## REMARKS

The Examiner's requirement for election/restriction is noted. Applicant's attorney spoke with the Examiner on March 11, 2005 and subsequently filed an Amendment (Election/Restriction) on March 25, 2005 electing with traverse Invention I, the specie represented by Figure 13, deeming that Claims 1-11 read on the elected species. Such election is reiterated herein along with the arguments previously presented.

FIG 19

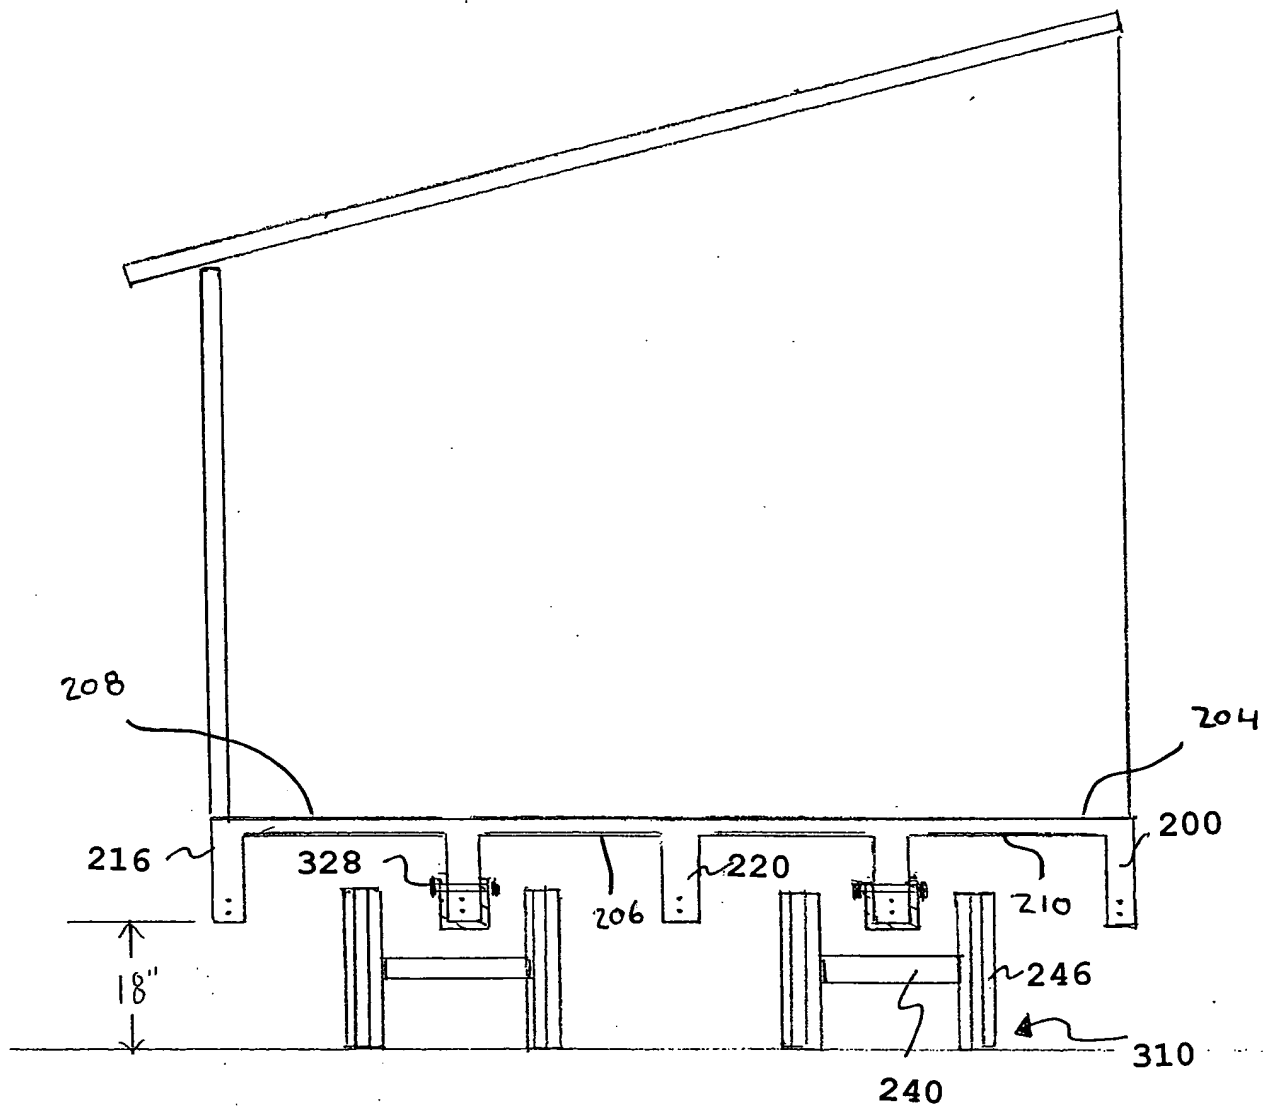
Eubanks teaches a concrete slab that does not have a forward and rearward edge, but only has two side edges. The side edges (#23, Fig 1) do not provide any front to rear rigidity as they only meet with side to side reinforcement members. Contrast that Eubanks with Figure 19 of the current application. It can be readily seen that in the present invention there are many lengthwise reinforcements that provide much greater resistance to flex during transport, and hence, eliminates cracking. Eubanks lacks, as does Davie, the teaching of a diaphragm header. Eubanks teaches a side edge, but no front and rear edge.

FIG 25

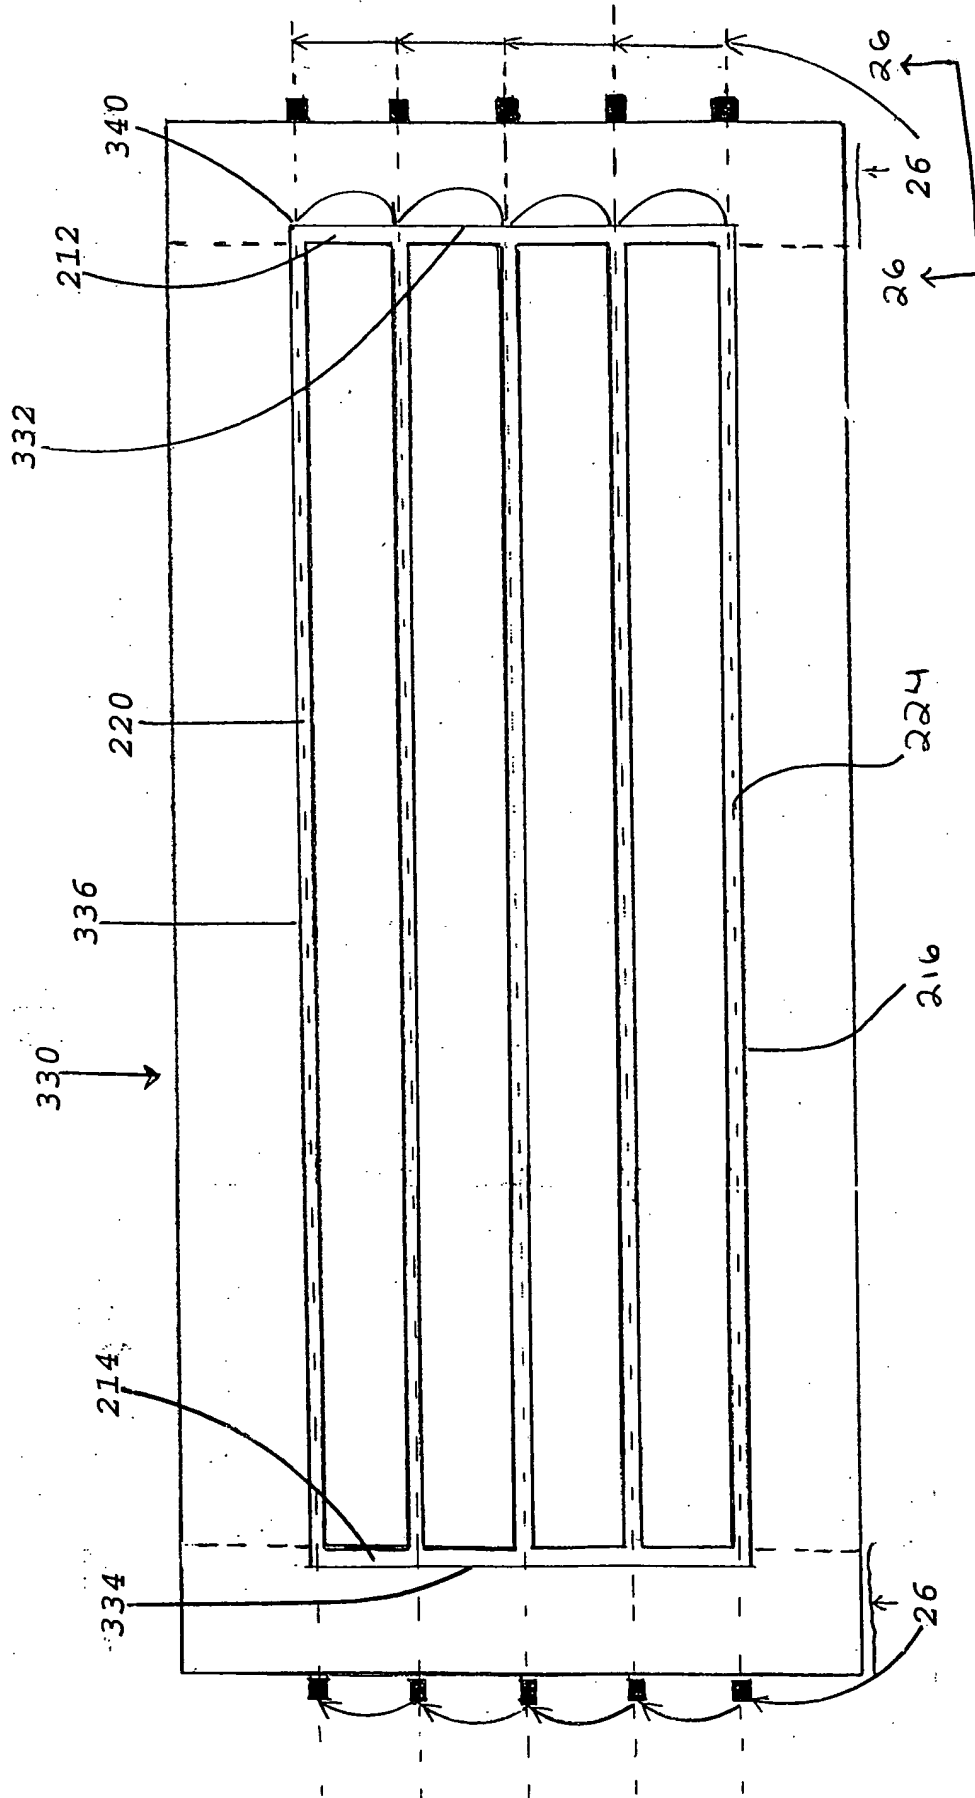
The Examiner's objections to the drawings are noted. In response thereto, appropriate additions have been made to the attached drawings in red for the Examiner's approval to bring the drawings in accord with the specification as filed. New formal drawings are submitted herewith for the Examiner's approval. These changes include the numbering of circle 15 in Figure 13; three additional lines, 19-19, 20-20 and 21-21, to indicate view direction in Figure 18; four additional reference numerals, 204, 206, 208 and 210, in Figure 19; section line 23 in Figure 22A; five additional reference numerals, 224, 228, 230, 234 and 236, in Figure 23; two additional reference numerals, 216 and 224, and a direction line 26-26 in Figure 25; and one additional reference numeral 216 and a direction line 29-29 in Figure 28.
